DESIGN MEMORANDUM NO. 8

COOPER RIVER REDIVERSION PROJECT
LAKE MOULTRIE AND SANTEE RIVER
SOUTH CAROLINA.

RELOCATION OF
SEABOARD COAST LINE
RAILROAD BRIDGE

SUBJECT: Cooper River Rediversion Project, Lake Moultrie and Santee River, South Carolina, Design Memorandum No. 8, Relocation of Seaboard Coast Line Railroad Bridge

SCL RAILROAD BRIDGE COOPER RIVER REDIVERSION PROJECT

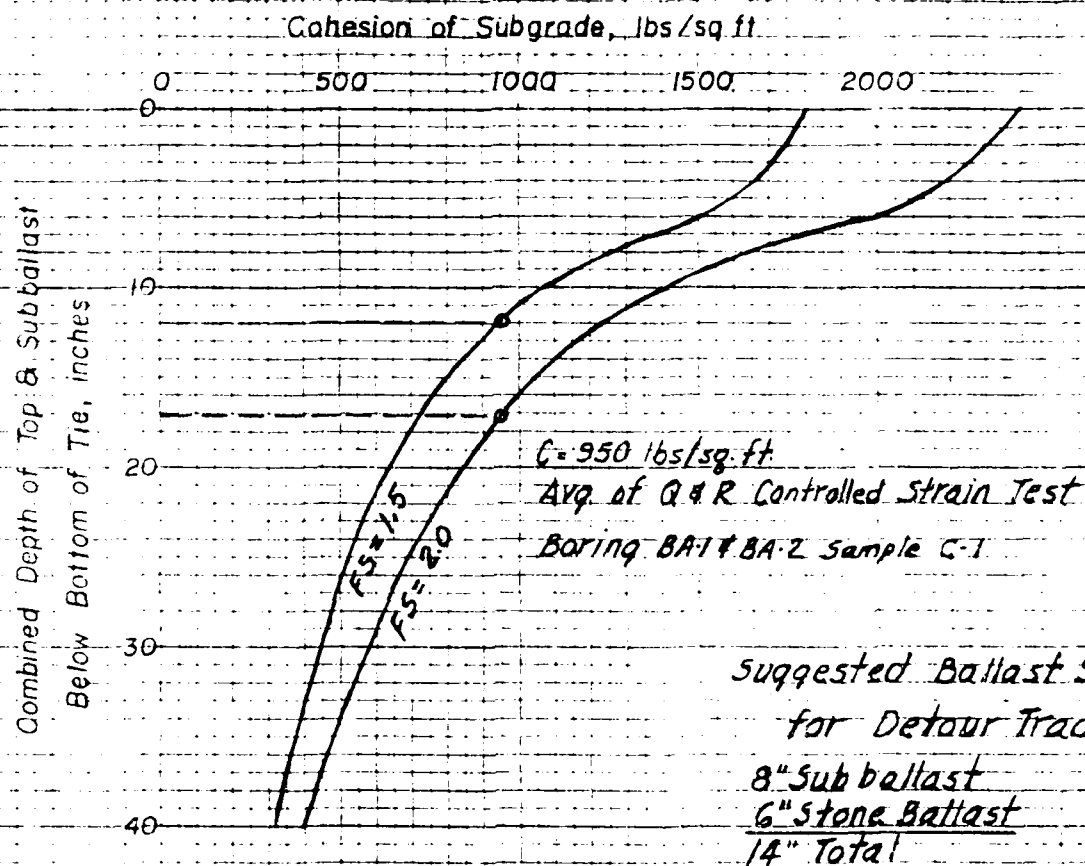
3. Paragraph 1c. The ballast section indicated for the detour track
and the rebuilt main track behind each new abutment is the current SCL
Railroad standard. The SCL Railroad has advised that they recognize
that their current standard section does not provide an adequate depth
of ballast and sub-ballast and they are in the process of revising their
standard. The final plans will provide a depth of ballast and sub-
ballast consistent with the new standard to be adopted by the SCL Railroad.
Only about 20 feet of the main track behind each new abutment will be
disturbed during construction and will require complete rebuilding of
the ballast section. The remaining work on the main track consists only
of grade adjustment which should not require roadbed design. The short
sections of roadbed embankment will be constructed with material from
the borrow pit compacted at optimum water content for maximum density.

WALKWAY SECTION

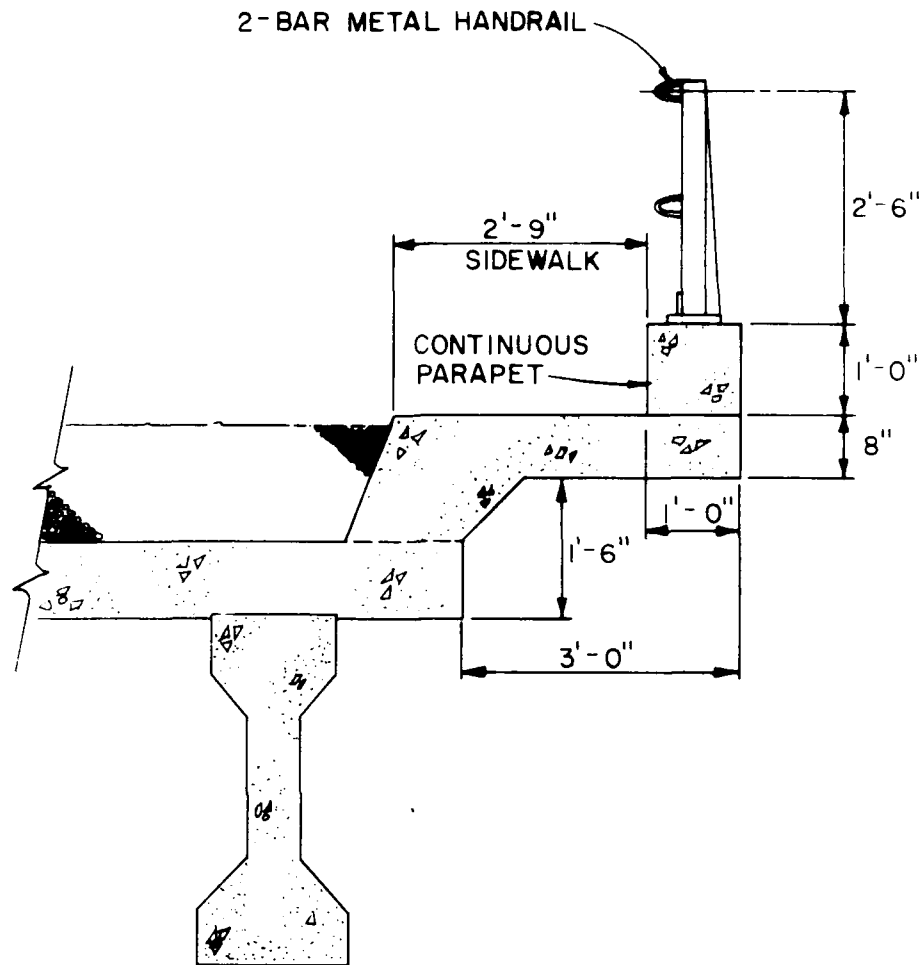
1. It is proposed that a walkway be added to the east side of the railroad bridge. A typical section is shown on the inclosed sketch. As standard procedure, the SCL Railroad has instigated the practice of constructing walkways on at least one side of all new structures and on all deck replacements of existing structures. The refuge bays currently included on the bridge would be deleted if the walkway is added.
